Amendments to the Drawings

Attachment: Replacement Sheet
Annotated Marked-Up Drawings

REMARKS

FIG. 3

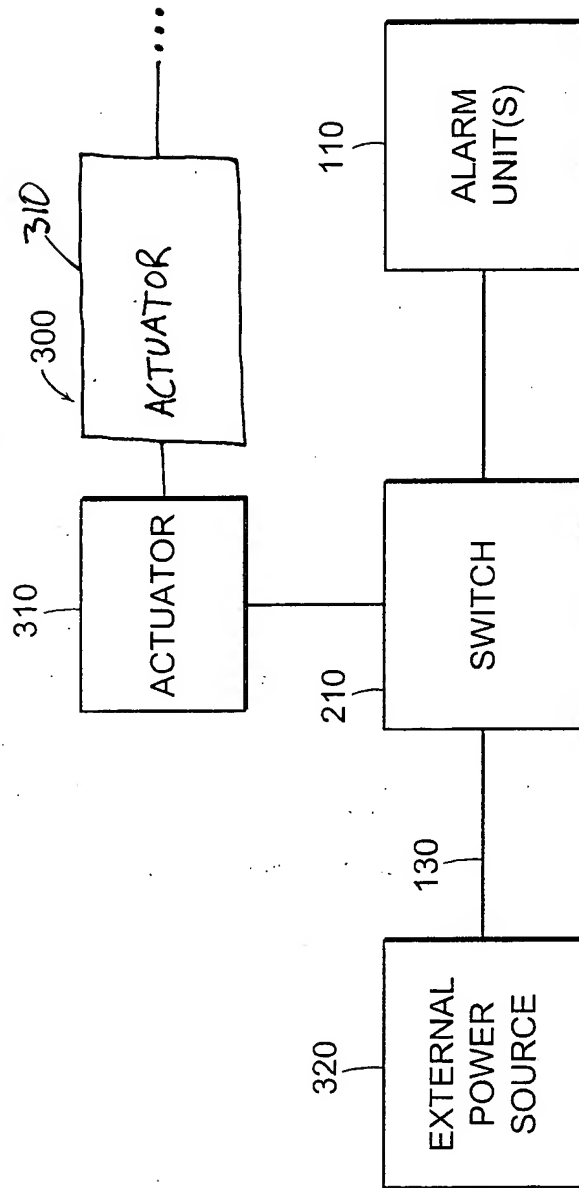
Fig. 3 is being amended to include (i) a second actuator that connects to the first actuator 310 and (ii) ellipses representing other actuators that may connect to the second actuator.

The drawings stand objected to under 37 C.F.R. 1.83(a) because they do not show every feature of the invention specified in Claim 14. Claim 14 recites “at least a second actuator remote from and coupled to the first actuator for providing an alternate location for temporarily interrupting the power supplied to each alarm unit.” Fig. 3 is now amended to include (i) a second actuator that connects to the first actuator 310 and (ii) ellipses representing other actuators that may be connected to the invention system. Support for these amendments is found at page 3, lines 26-28 and page 6, lines 18-19 of the Specification as originally filed. No new matter is being introduced by way of these amendments. Applicants respectfully submit that these amendments overcome the objection to the drawings. Acceptance is respectfully requested.
